BOARD ACTION REPORT – APPEALABLE ITEM

Project Name: 1020 Langer Way
Project Location: 1020 Langer Way
Request: Class V Site Plan
Board: Site Plan Review and Appearance Board
Meeting Date: December 14, 2016

---STAFF REPORT---

ITEM: 1020 Langer Way – Class V Site Plan associated with demolition of existing site and construction of 3-unit fee simple townhome development with a swimming pool and 2-car garage serving each unit.

SITE PLAN

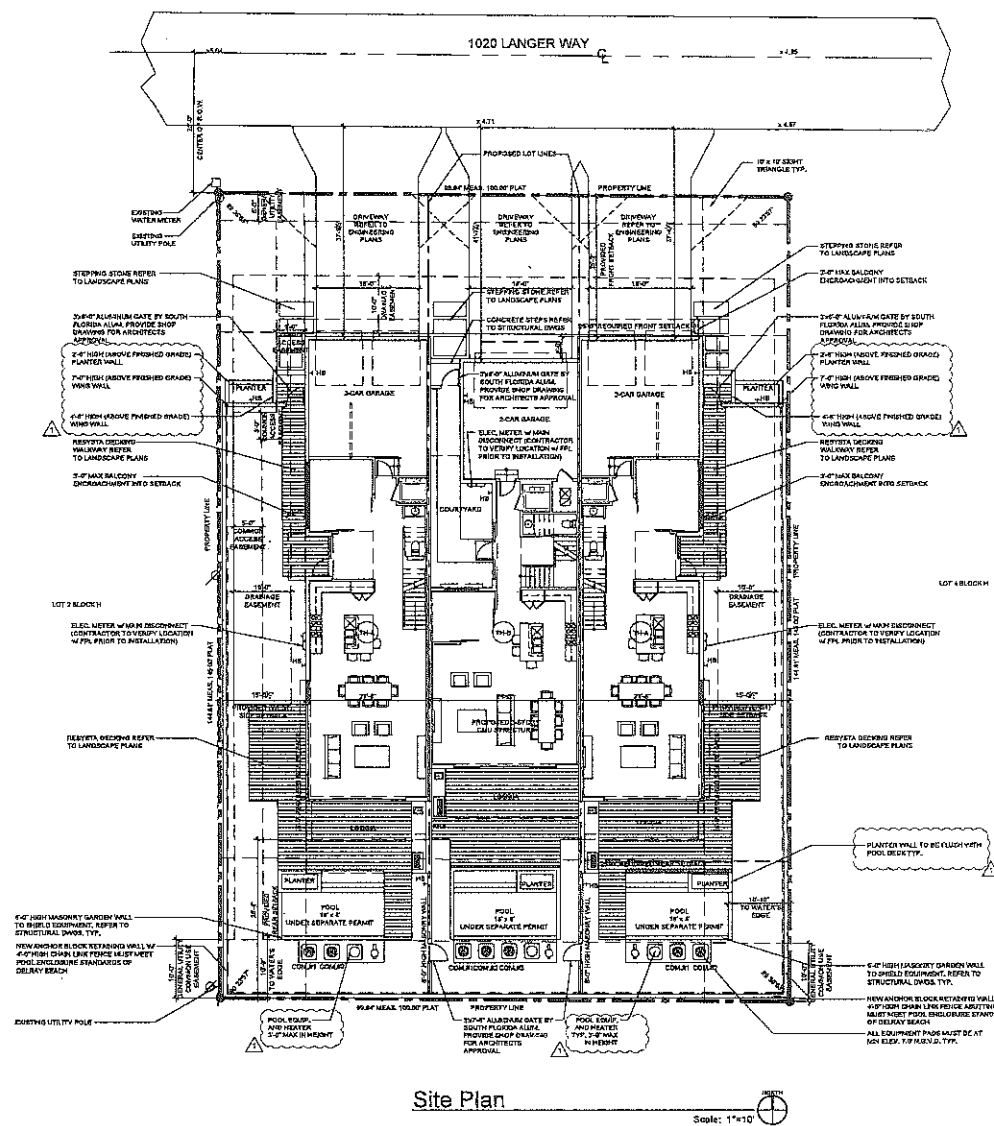
2. The Site Plan and Engineering Plans show numerous easements and appears to split the property into 3 sub-parcels. A plat to create these parcels, easements, and to identify who the easements and parcels are in favor of.

3. The plan sheet needs to show the location of the nearest driveway or point of access of adjacent properties (including property across a street, which shares a common street with the subject property). If there are no driveways within 50', then they do not need to be shown; however, a note to this situation shall be provided.

4. The water meter for the site appears on the survey to be located in the NW corner of the site and not on the NE corner as shown on the Civil Plans.
5. The note on the Paving and Drainage Plan states that "contractor to verify size, material & location" of the water service. The size of the existing water meter must be verified prior to site plan approval as a 5/8" or 1" meter will not be sufficient for three three-story structures.

7. There is a perimeter berm shown on the plans at elevation 5.60. There is an inlet in the NW corner of the site at elevation 5.00. This would appear to allow the water to flow off the site at el. 5.00 and not retain stormwater at the perimeter berm elevation. Suggest a control structure to keep required water on-site.

8. A detail is provided for trench drain but it does not appear on the plan. Is it intended to be placed somewhere?
9. As there is currently no sidewalk on Langer way, it would be inappropriate to construct a sidewalk concurrent with development. The applicant must fund the cost of constructing the sidewalk In-Lieu of constructing the sidewalk along the project frontage. These funds will be escrowed and used for the installation of the sidewalk by the City at a later date.
